Tom Cat Designs LLC Protective Hull Modeling & Simulation CORRECTED Results For Iteration 1

Sebastian Karwaczynski

23-May-2012

Fit and Function Analysis 9°

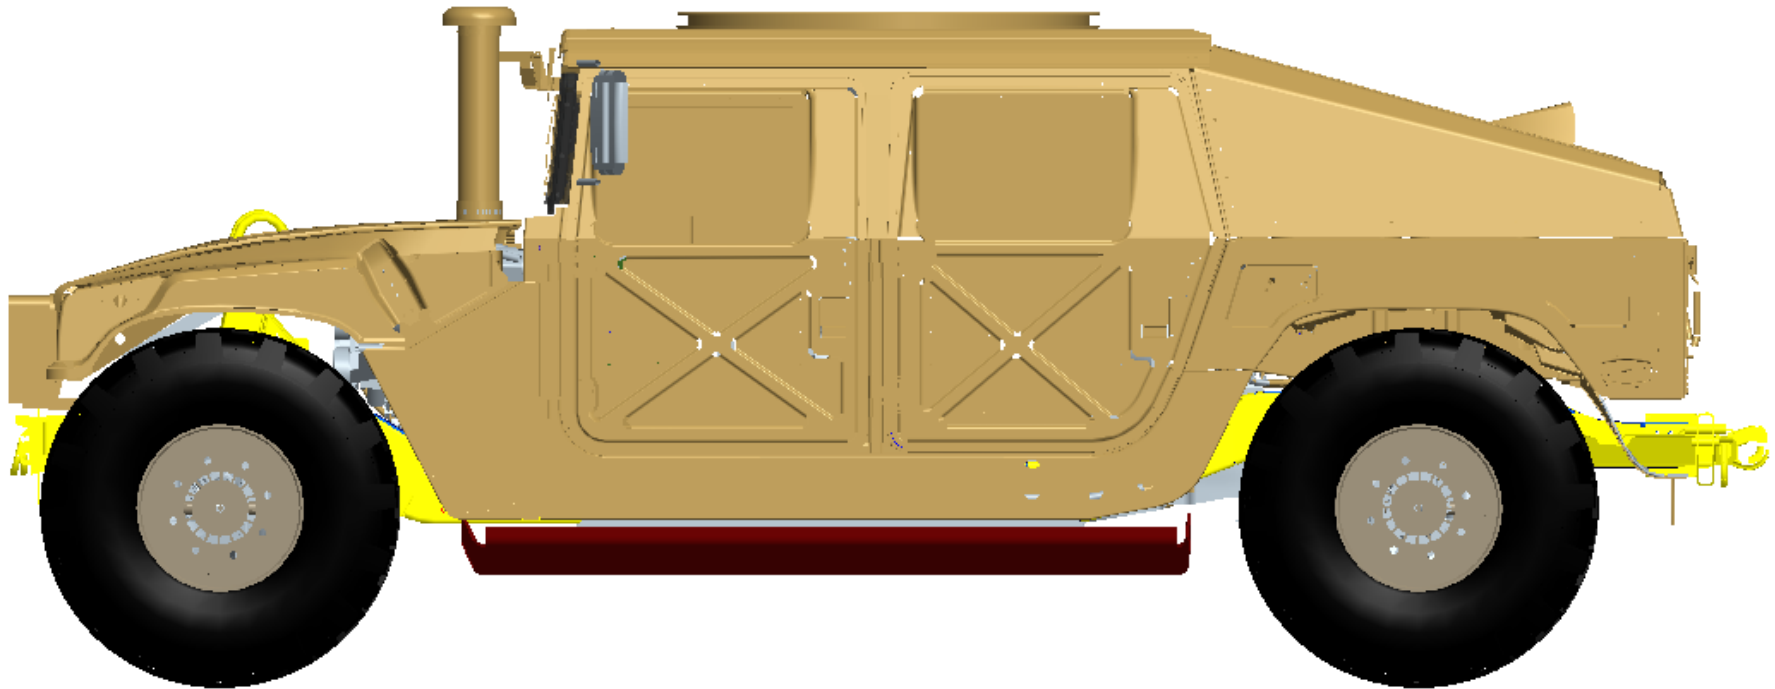
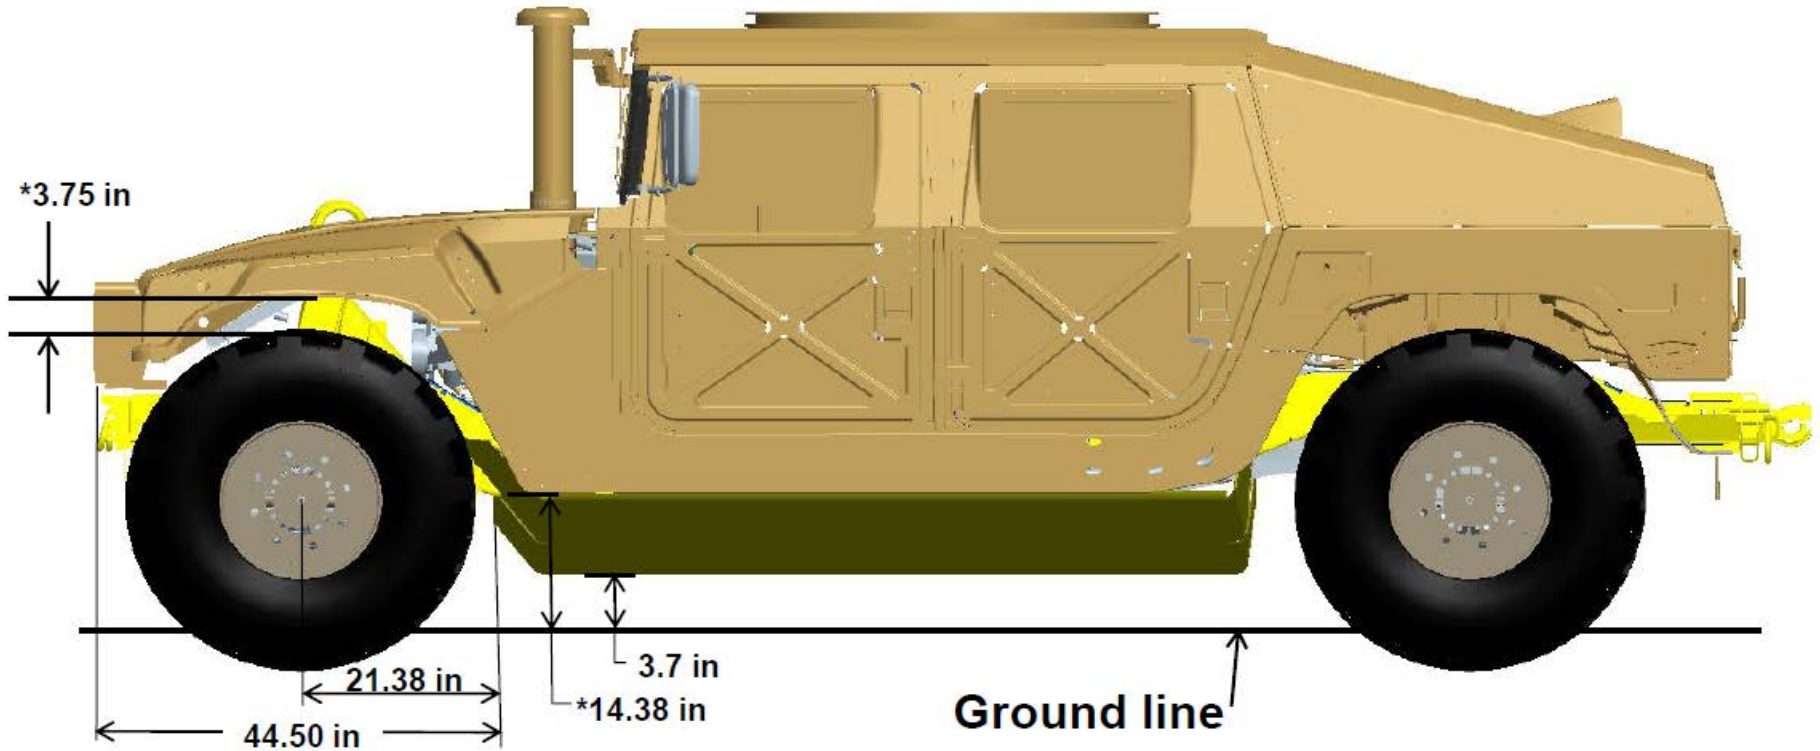
- During installation/removal of the underbody kit, the attachment locations are potentially difficult to reach.
- All 8 bolts are blind operation.

Fit and Function Analysis 9°

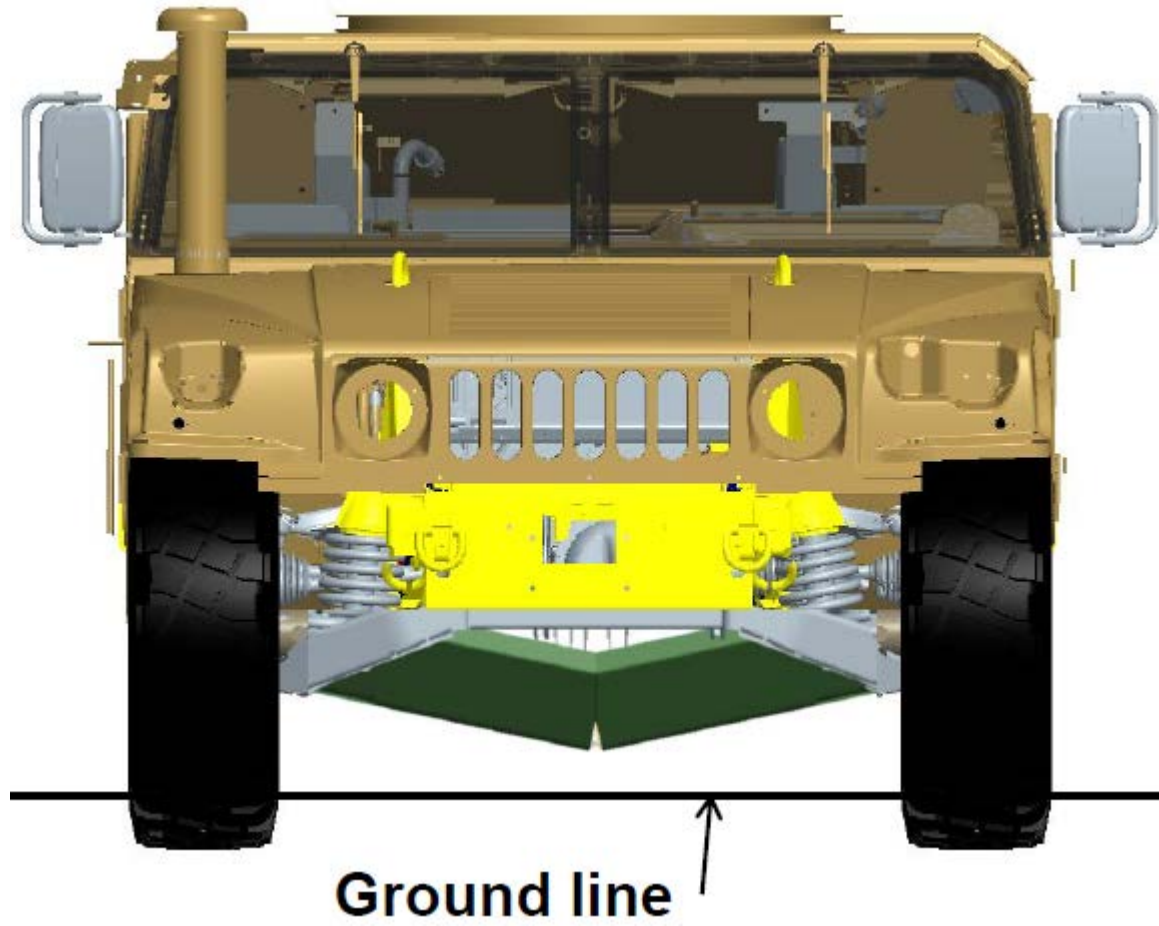
- During installation/removal of the underbody kit, the attachment locations are potentially difficult to reach.
- All 8 installation bolts are blind operation.
- Ground clearance is significantly reduced with the 24° belly plate
